**ADDENDUM NO. 1**  
TO  
PROCUREMENT AND CONTRACTING REQUIREMENTS  
FOR  
**Riley Village Sanitary Sewer Project (Both Divisions)**  
FOR  
NINESTAR CONNECT  
Issue Date: April 17th, 2024

**Project Name:** Riley Village Sanitary Sewer (RD and RD Exclusion Divisions)

Re: Task Order No. 7 – Riley Village Wastewater Collection System Investigations,  
CCTV Review

**EXHIBIT B-1**  
**Existing Wastewater**  
**Collection System Map**

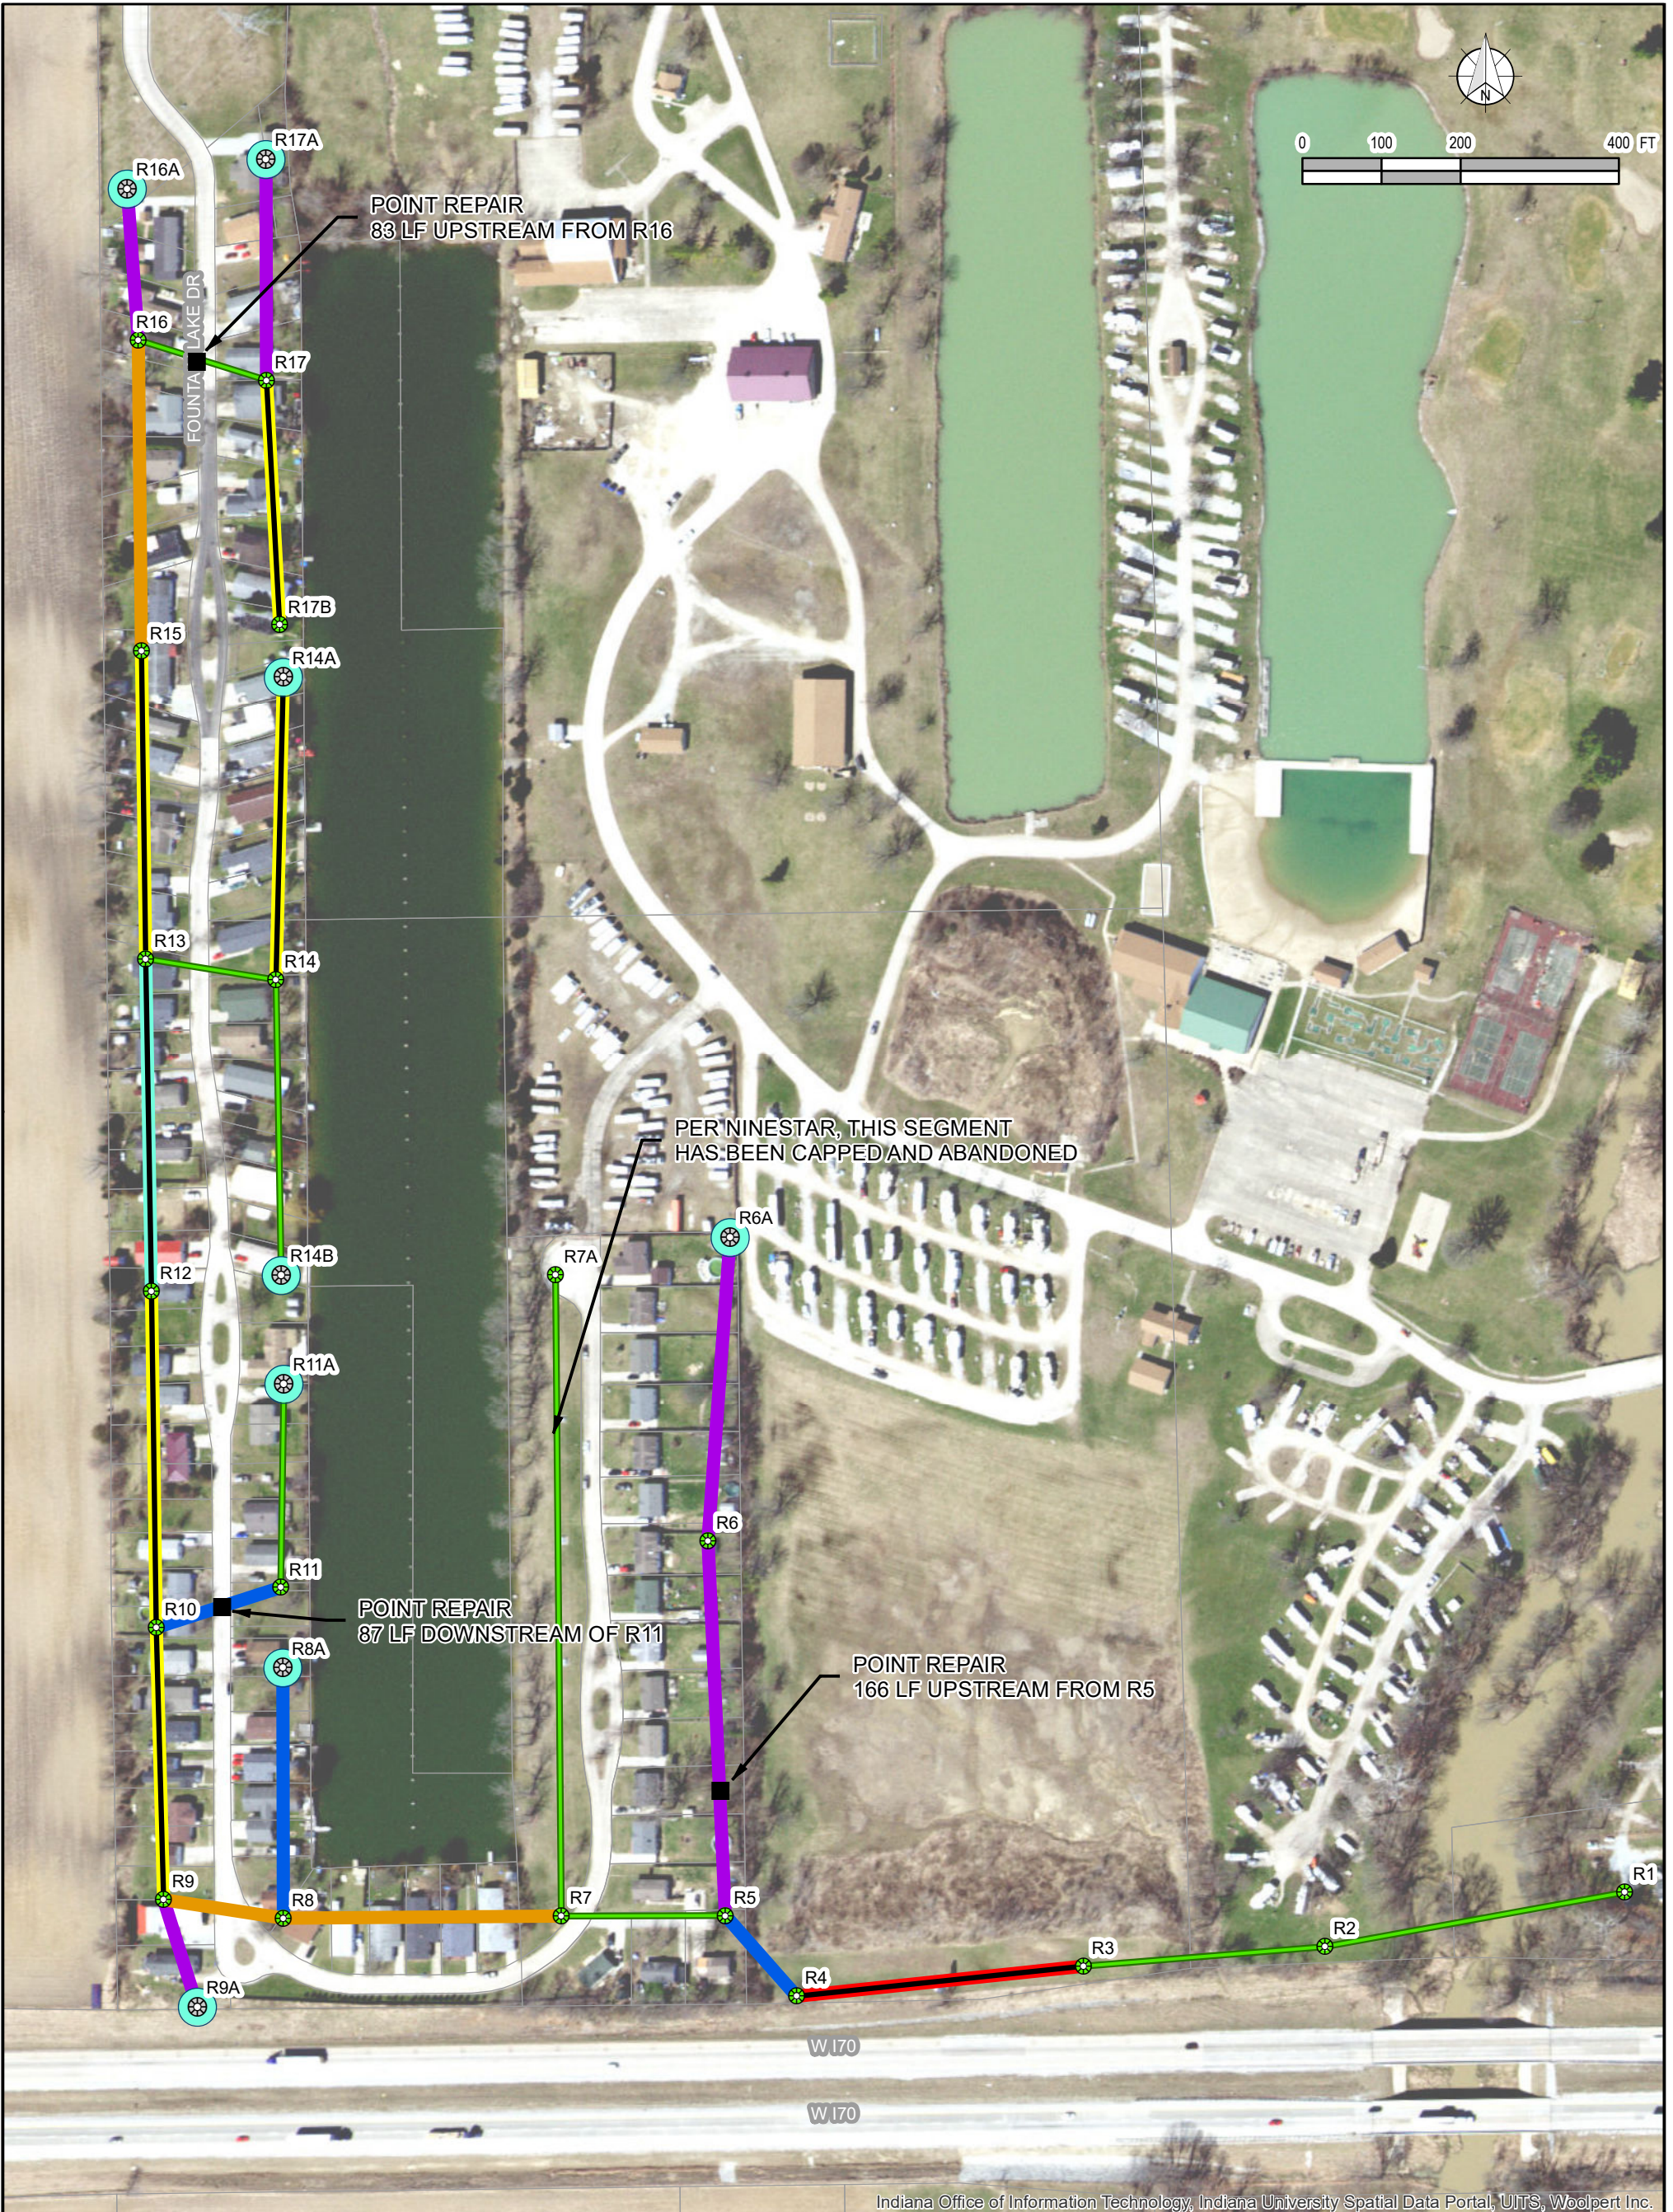
The existing wastewater collection system consists of PVC and truss pipe with one (1) ductile iron segment. Of the 26 segments, 19 segments run under homes and nine (9) are undersized per Indiana Administrative Code 327 3-6-8 (minimum 8 inches in diameter). Please refer to the attached *Exhibit A – CCTV Review and Recommendations*, as well as *Exhibit B-1 – Existing Wastewater Collection System Map*.

**EXHIBIT B-2**  
**Short-Term Recommended Improvements**

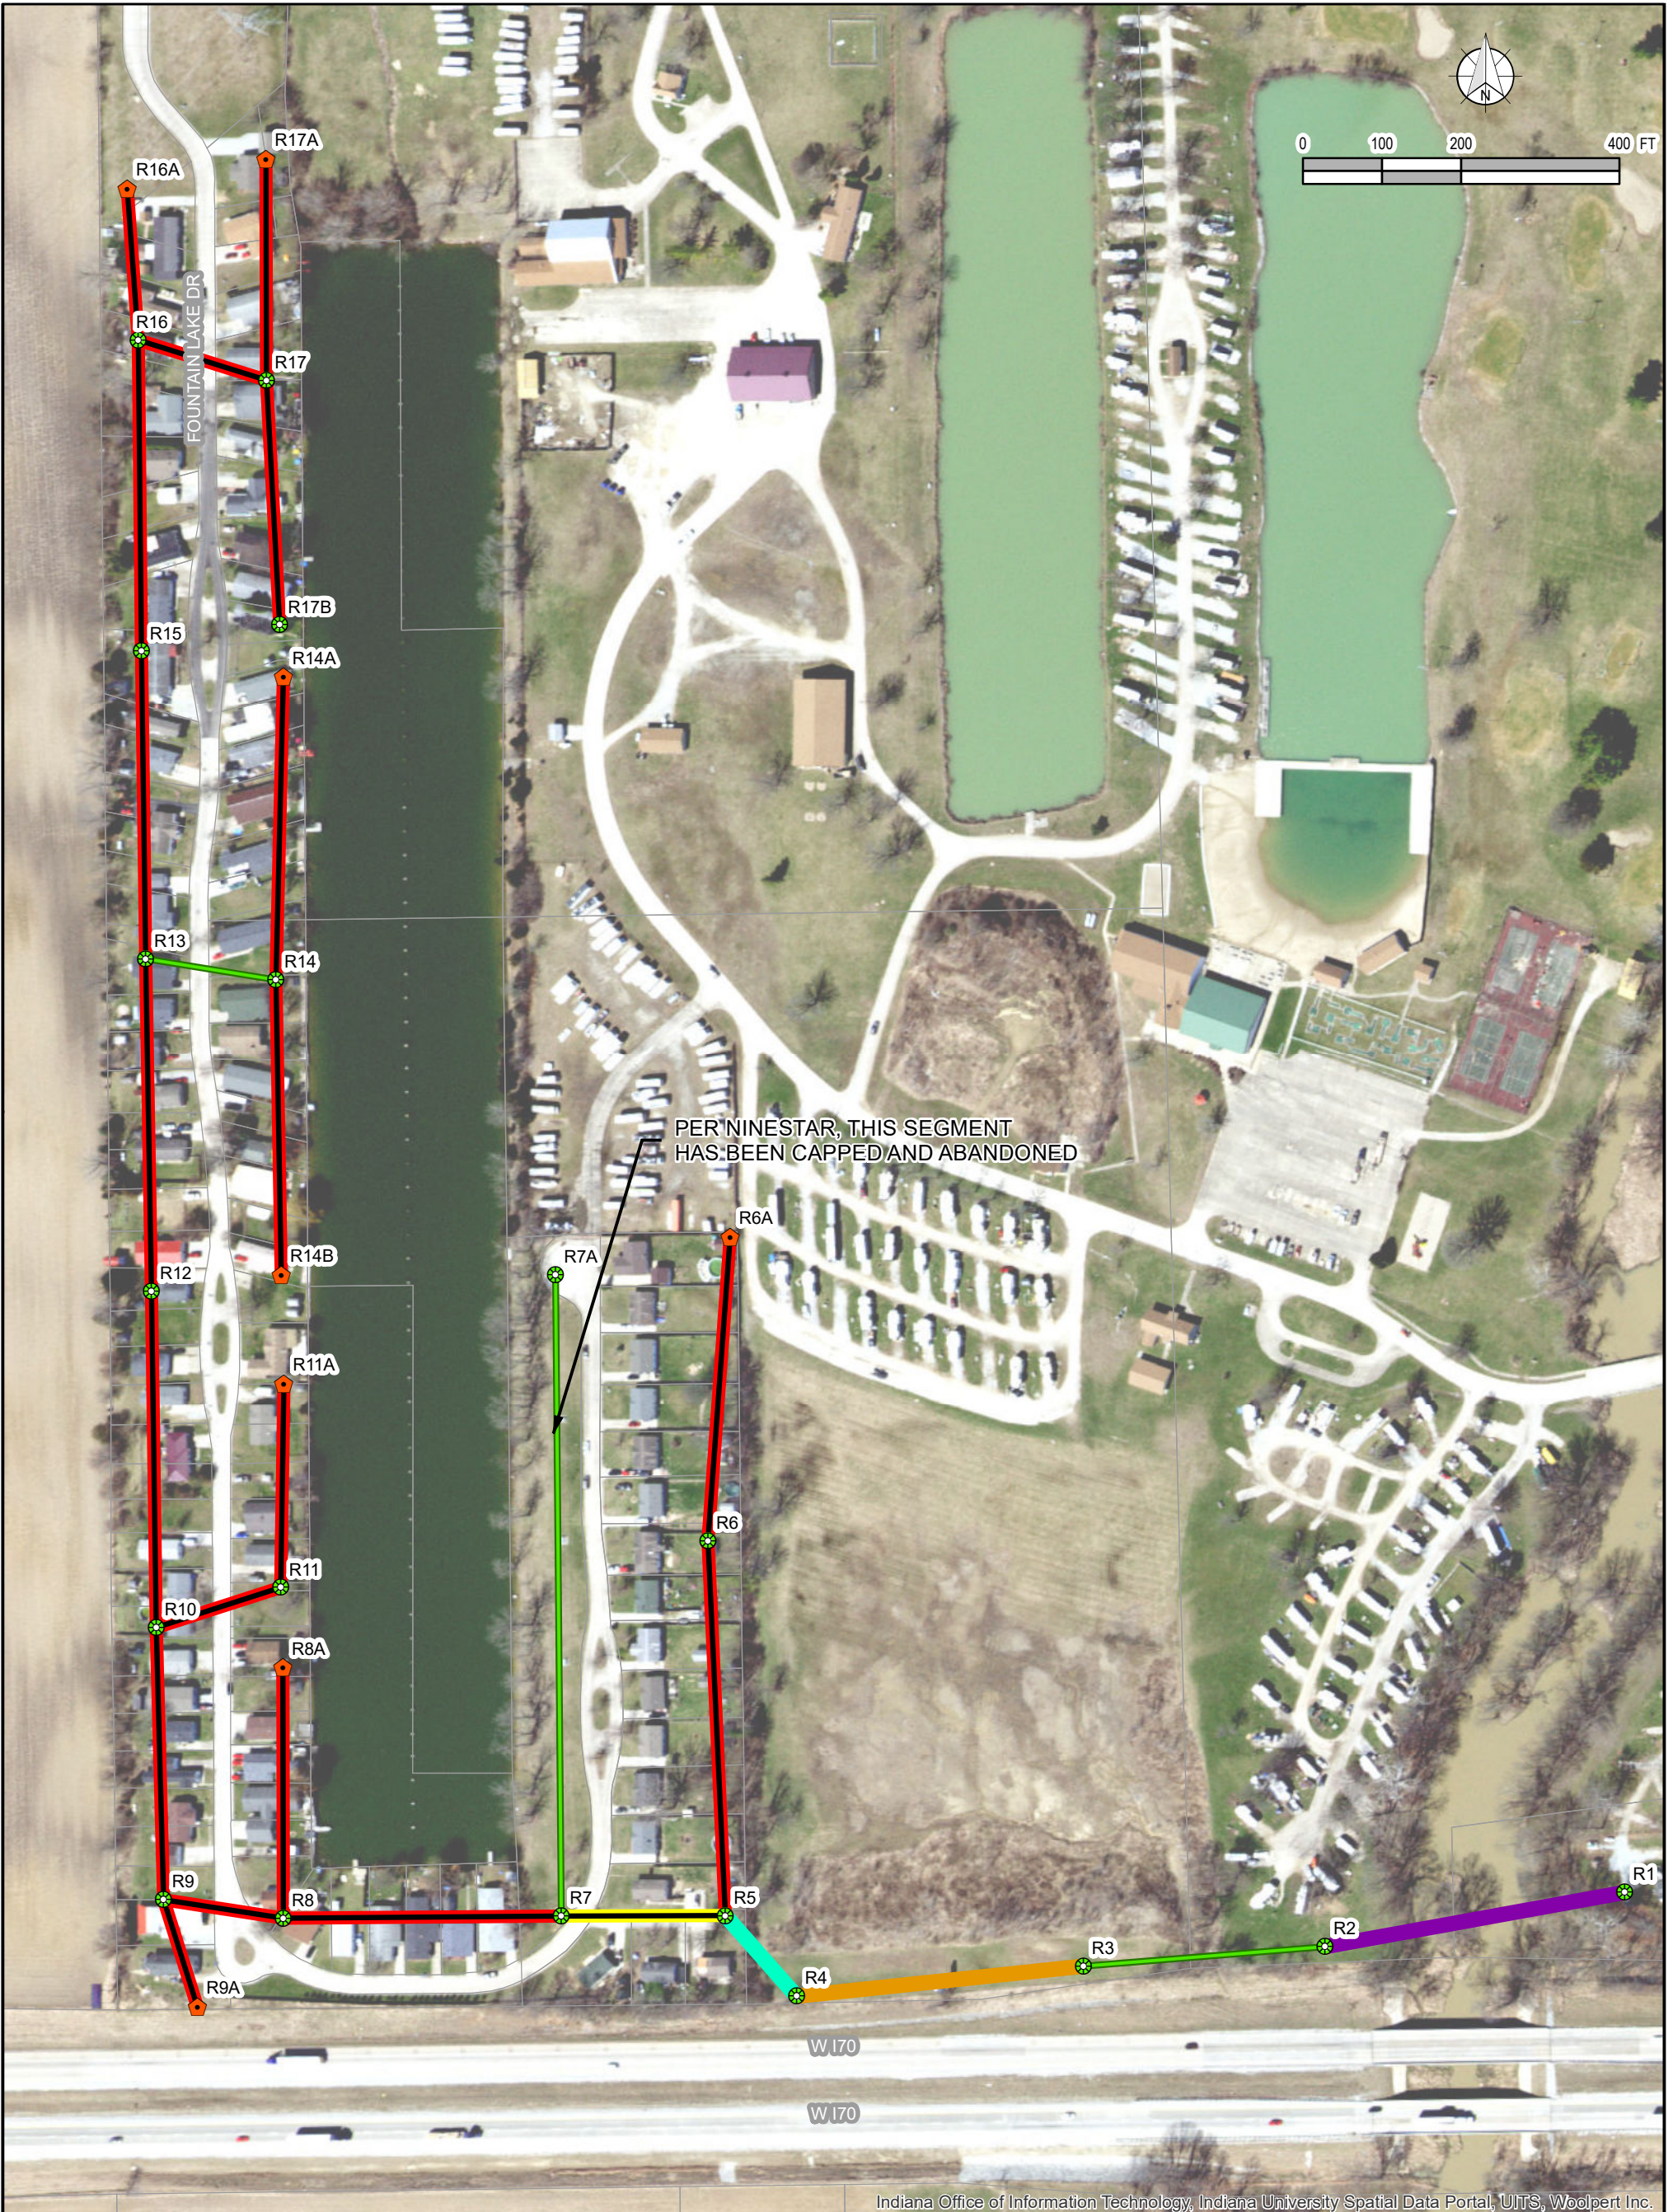
The total estimated construction cost for all Short-Term Recommended Improvements is **\$308,750.00**. Refer to *Exhibit B-2 – Short-Term Recommended Improvements* for a graphical display of this work.
